TOWN OF YARMOUTH
200 Main Street, Yarmouth, Maine 04096
www.yarmouth.me.us

Planning Board Report
Railroad Square Master Plan
Preliminary Plans for Development Plan & Major Subdivision
Railroad Square Associates, LLC, Applicant
Map 37 Lots 28 and 29A; CD-4 Village Center Character District
Prepared by Erin Zwirko, Director of Planning and Development
Report Date: July 14, 2022; Planning Board Date: July 20, 2022

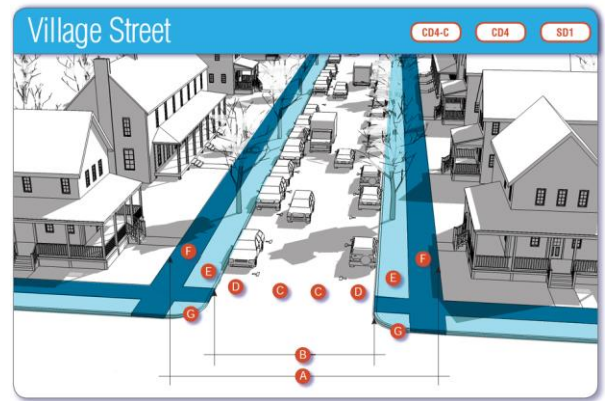
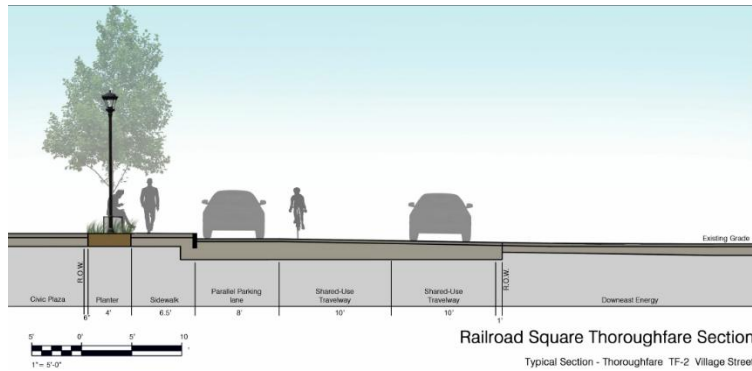
Thoroughfare TF-1: The Road Thoroughfare is technically not a Thoroughfare option for the CD-4 District, where Railroad Square is located, as only SD-1 appears in the heading of Table 6.E.2B (see the illustration above). However, it is likely the best fit to apply appropriate Thoroughfare standards to this existing condition at the intersection of Railroad Square and Main Street and for the first 120 feet of the access into Railroad Square. The Planning Board agreed and granted a waiver with the Preliminary Development Plan and Subdivision Plan for its use.

The condition is along the shared easement with Down East Energy, two 10-foot shared travel lanes, and one 6-foot sidewalk is proposed. The applicant indicated in its submission for the April 27th meeting that these travel lanes would be reduced to 10 feet. The Final Plan and Sections still show 11 foot travel lanes. This needs to be corrected.

No parking is proposed on either side of the roadway. No planter type is provided, although the existing conditions on both sides (Down East Energy and the pavilion) likely make this difficult to comply with this standard. As noted by the Bike and Pedestrian Committee there is a pinch point between the pavilion and the roadway. The applicant has shown the sidewalk at 6 feet adjacent to the pavilion, and the edge may blend into the base of the pavilion. An easement is shown on the Final Plan and executing that easement is recommended as a condition of approval.

The Bike and Pedestrian Committee previously pointed out the double crosswalk condition at the site entrance. As noted above, the Committee's first priority recommendation is to create an extended table at sidewalk level through these two crosswalks. The Planning Board may want to hear the applicant's reaction to this recommendation during the meeting on July 20, or this coordination and layout can be part of the required coordination for the intersection plan as a condition of approval.

painted fog line would be used, the Final plan suggests the use of a stamped or bituminous pavement with a textured design. However, this is not shown on the Final plans and must be corrected.

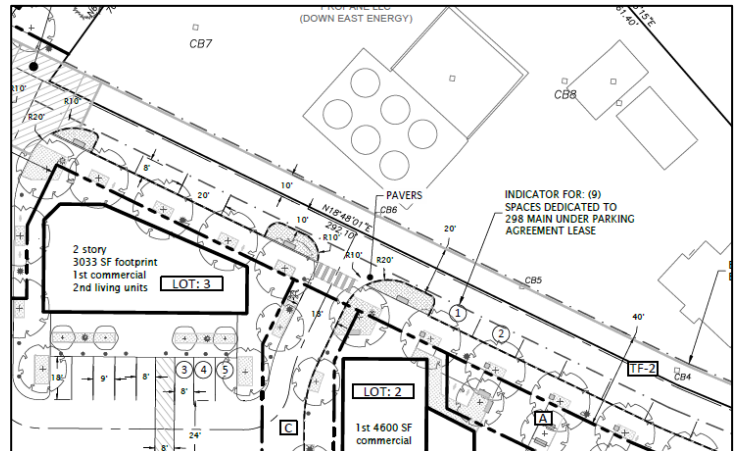
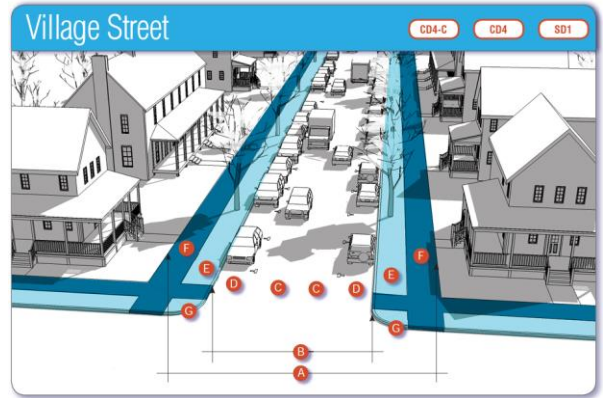
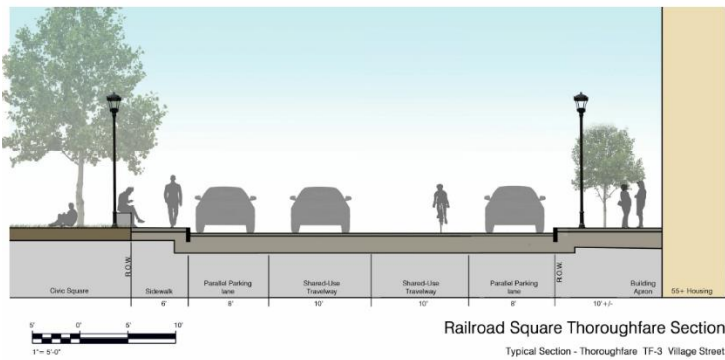
Thoroughfare TF-2: The Village Street is a Thoroughfare type allowed in the CD-4 District. The section provided in the March 23 materials meet the requirements for a Village Street as outlined in Table 6.E.2F, including for the type, assembly, planter, and walkway. Lane widths have been reduced to 10 feet from the previously proposed 11 feet. The curb radius for a Village Street is 5-10 feet; the developers are showing 10 feet and 20 feet. Pavers are used to narrow the radius to the 10 feet.

The Town's peer reviewer is now satisfied that the 6-foot sidewalk will be sufficient given the sidewalk amenities illustrated in the. Based on the updated Development Plan materials, the applicant located the street trees, bike racks, and light poles to the back of the 6 foot sidewalk, and final Thoroughfare sections confirm that condition. Parallel parking is proposed and is an allowed element in the Village Street Thoroughfare.

As shown on the Final Development Plan, the TF-2 includes curb extensions at the Passage C and where TF-2, TF-3, and TF-4 meet. The applicant has incorporated a raised table at the intersection of TF-2, TF-3, and TF-4 meet, and a detail has been provided for this raised table and crosswalk illustrating the appropriate and safe separation between vehicles and pedestrians in this location.

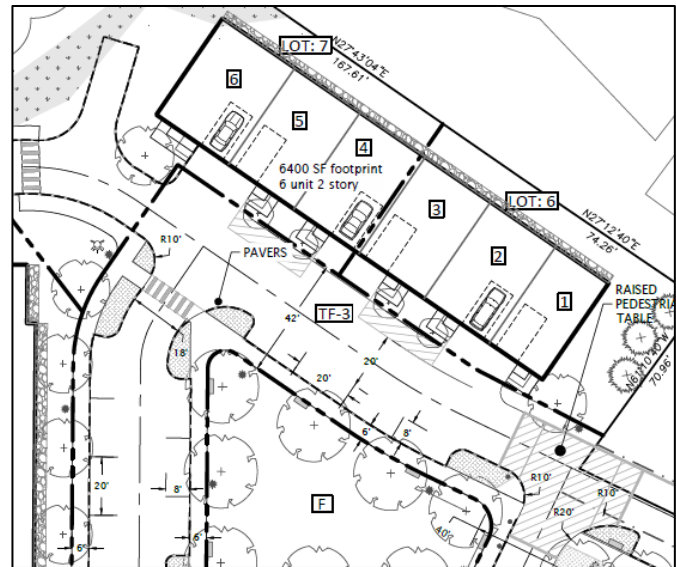
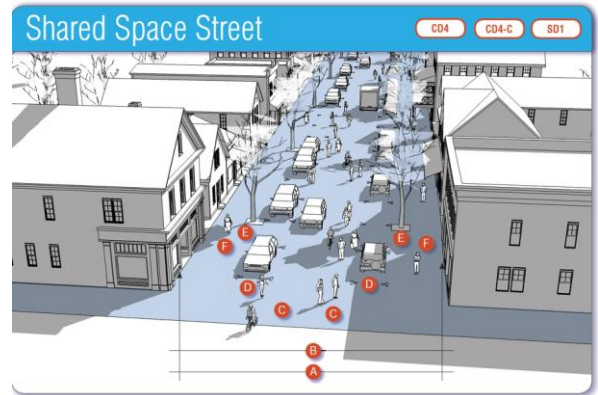
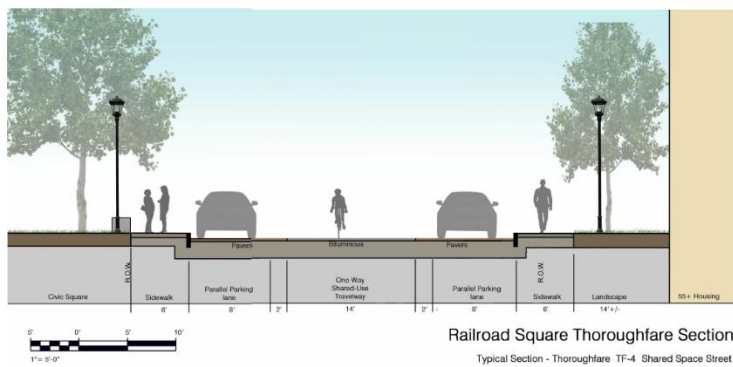
Thoroughfare TF-3: TF-3 also utilizes the Village Street. The section provided in the March 23 materials meet the requirements for a Village Street as outlined in Table 6.E.2F, including for the type, assembly, planter, and walkway. Lane widths have been reduced to 10 feet from the previously proposed 11 feet. The curb radius for a Village Street is 5-10 feet; the developers are showing 10 feet and 20 feet. Pavers are used to narrow the radius to the 10 feet.

TF-3 spans the area between the Civic Square and the six carriage house units on Lot 6 and Lot 7. It also intersects with the driveway to the underground parking serving Lot 4 and Lot 5 as well as the TF-4 Shared Space Street on the opposite side of the Civic Square. The Town's peer reviewer previously suggested that the 6-foot sidewalk width on the west side may not be sufficient given the Public Frontage amenities, but with the additional 4-foot building apron it should be acceptable. The Planning Board discussed this condition at the April 27th meeting and appeared to find consensus that the Board members did not think it was necessary. The peer reviewer continues to suggest that these areas become raised with a mountable curb so that they do not simply become parking areas.

The Planning Board previously discussed how the rear of Railroad Square becomes primarily residential and private. At the intersection with the driveway to the underground parking, the transition from public to private is more stark as it only provides access to private parking. The driveway was narrowed to 18 feet, and resulted in some loss of parking, but a revised parking table was submitted with the Preliminary Plan illustrating that there continues to be compliance with the required parking amounts. Should a non-resident travel down the driveway, there are spaces available for a driver to turn around.

At the transition to TF-4, a change in the pavement, a change in canopy with street trees proposed on both sides of the Thoroughfare, and the Public Frontage amenities should suggest to motorized and nonmotorized traffic that there is a distinct residential appearance. A raised pedestrian crossing is not specified at this location, but a paver apron is shown to reduce the curb radius.

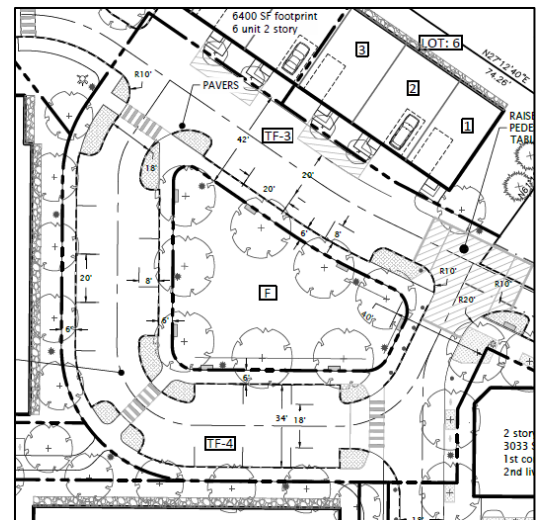
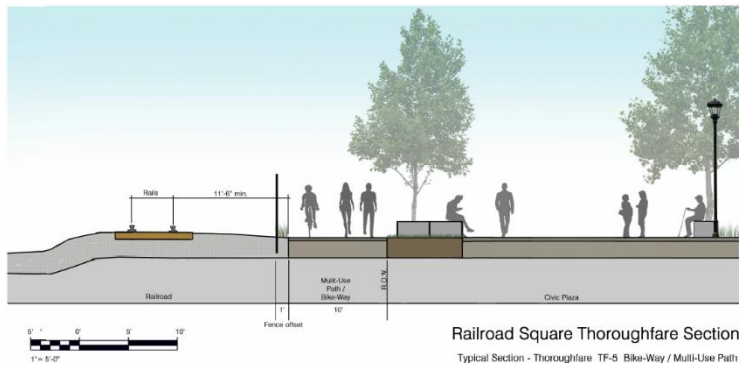
Thoroughfare TF-4: TF-4 utilizes the Shared Space Street, another Thoroughfare type allowed in the CD-4 District. The section provided in the application materials meet the requirements for a Shared Space Street as outlined in Table 6.E.2F, including for the type, assembly, planter, and walkway. The one-way condition is not necessarily envisioned in the CBDC but supports the intention of the Thoroughfare type. Also note that the sidewalk is curbed, so it does not provide exactly the freeflowing motorized and nonmotorized traffic envisioned for a Shared Space Street (see the illustration above) since the sidewalk is still separated from the travel and parking lanes.

The Fire Department previously indicated that there needs to be 20 feet of obstructed width per the NFPA regulations. After much discussion on this Thoroughfare, the applicant has adjusted the paved width to 14 feet (one-way) and extended the 8-foot parking aisle pavers out an additional 2 feet, so that the 14-foot drive aisle is flanked by 10-foot parking aisles as shown on the materials plan. The CBDC identifies a pavement width of 30 to 76 feet for a Shared Space Street; at 34 feet, the proposed TF-4 is consistent.

At the intersection of TF-4, TF-3, TF-2, and the parking area on Lot 3, there is concern about conflicts between motorized and nonmotorized traffic. One of the other Thoroughfare standards suggests in cases where there may be conflicts, the pedestrian access should be prioritized. The applicant has incorporated a raised table at the intersection of TF-2, TF-3, and TF-4 meet, and a detail has been provided for this raised table and crosswalk illustrating the appropriate and safe separation between vehicles and pedestrians in this location.

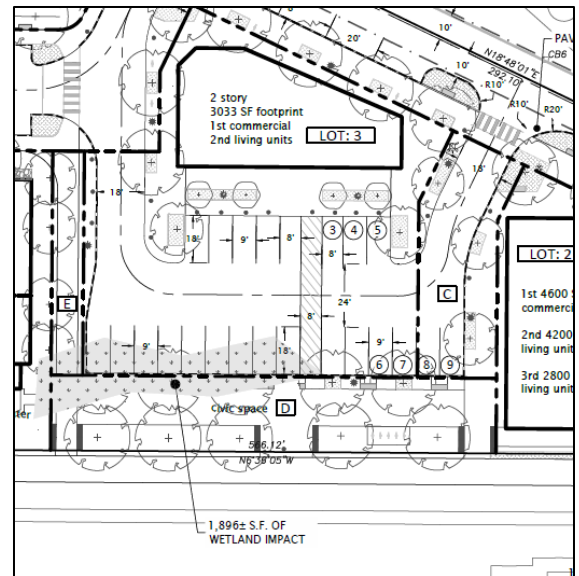
The Multi-use Path is a Thoroughfare type allowed within the CD-4 District. It is shown on the section as a 10-foot wide path, but as noted in the presentation to the Town Council for their endorsement, the demonstration trail concept includes:

- A 12-foot wide asphalt pathway approximately 1,250 feet in length and would be aligned with the siding rail in this stretch. This location was selected as it has the least amount of grade changes within the rail right-of-way cross-section.
- A small retaining wall and fence would be required along approximately 400 feet of steep bank along the right of way.
- A fence is also required for separation from the main rails under MaineDOT policy. However, it is anticipated that a request will be made to withhold installation of the fence until such time that there is tariff traffic pending on the line.

Because of the approvals needed from MaineDOT and the request to wait until the completion of the Advisory Council process, the demonstration trail may be constructed with a different timeline than the rest of Railroad Square. This is a key connection for the Crosstown Pathway and for the Casco Bay Trail, as well as for the Railroad Square development. The applicant has continued to be a partner to the Town and a condition of approval to continue supporting and coordinating is recommended.
